**PCN16-2019 (Change from Standard to Customized JEDEC Trays)
CMV20000 & CMV50000 product family**

Affected Devices / Product Family: CMV20000 & CMV50000

Comparison

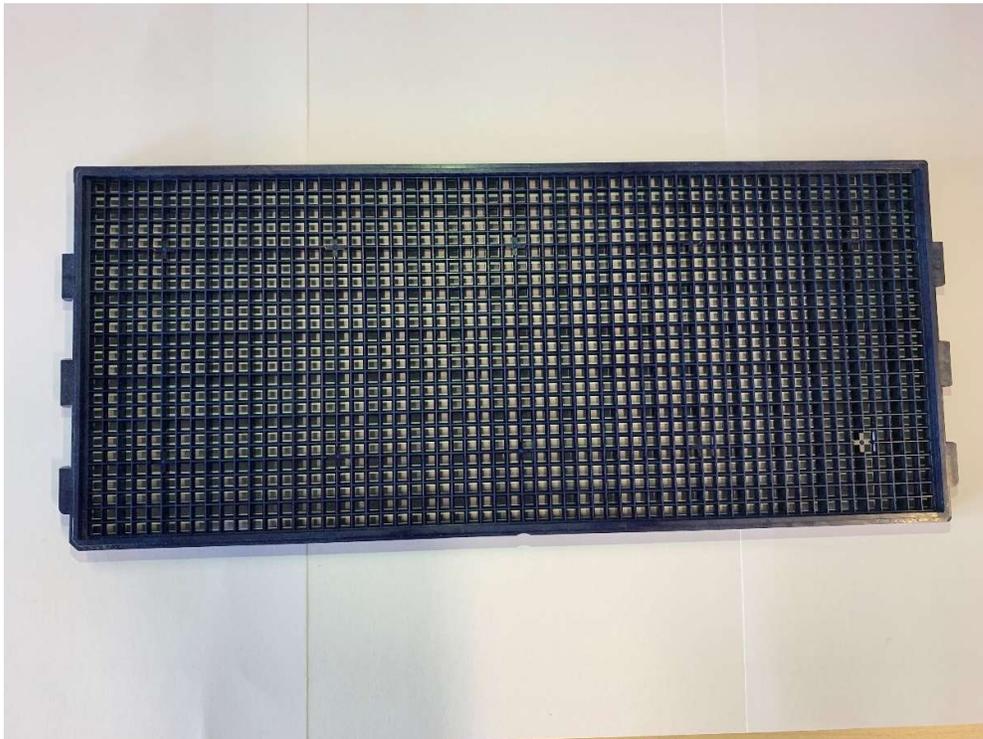
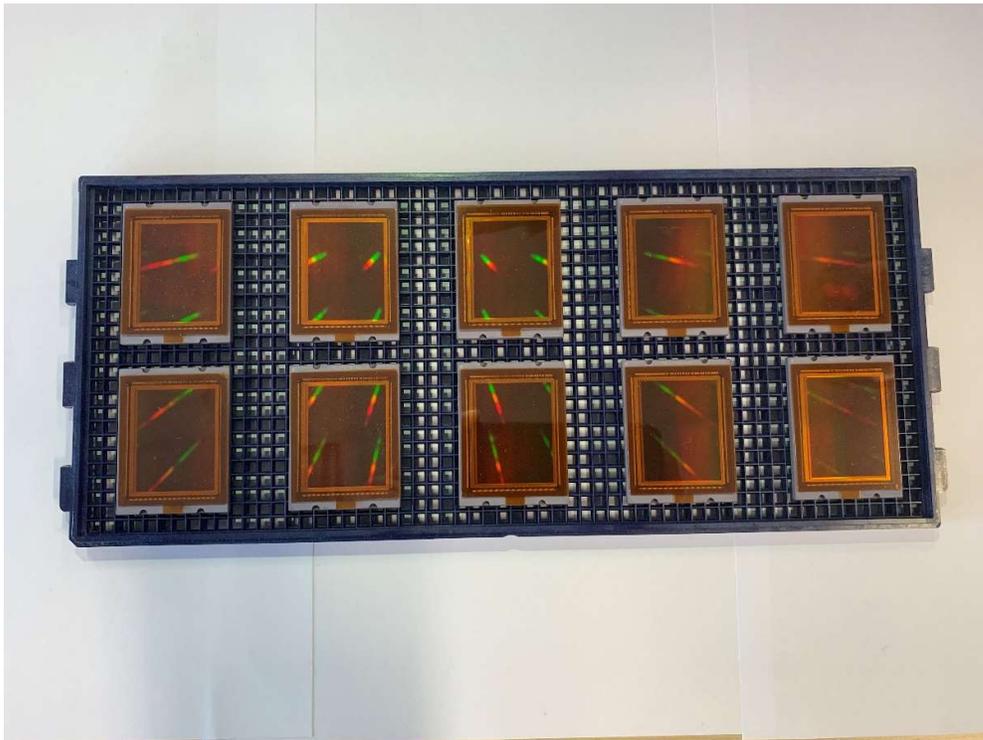
Please be informed that ams AG is changing the JEDEC trays for the packing of the CMV20000 & CMV50000 image sensor families. This change is not affecting any product specifications, only the packing form.

To avoid potential transport markings, ams will introduce customized JEDEC trays for the CMV20000 & CMV50000 product family.

The outside packing will change. A double-waved carton box will be used to ensure more stability during shipment. Moreover, the customized tray has an improved maximum baking temperature. From up to 50 degrees Celsius for the standard tray, the maximum baking temperature for the customized tray is up to 150 degrees Celsius.
